Part Change Notice: Detect Switch and Cover Plating Change

Part Number
ST11S008V4HR2000

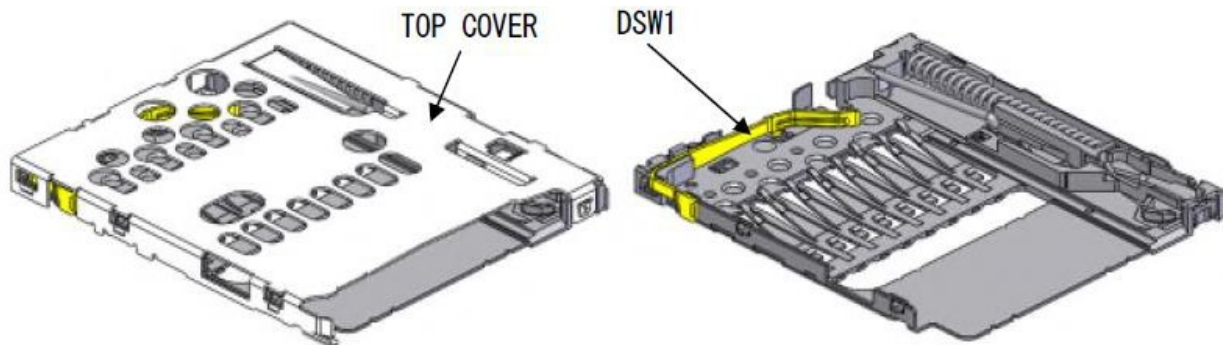
The current plating on the components works well in most conditions, but when used with solder with good wettability at low temperatures, DSW1 (detect switch 1) can potentially wick up solder and stick to the top cover which will not allow normal functionality of the detect switch.

In order to prevent this, the selective plating of DSW1 is changed to further limit the Au plating to only the necessary areas. Please see below for more details on the change.

The changes in plating do not affect the connector form, fit or function.

Part	Revision	Location	Specification
Top Cover	Current	Japan Factory	Au (0.03um min)
	New	Same factory, different line	Au (0.03um min) over Ni (0.5um min)
DSW1	Current	Japan Factory	Au (0.03um min) over Ni (1um min)
	New	Different Japan Factory	Au (0.03um min) over Ni (1um min)
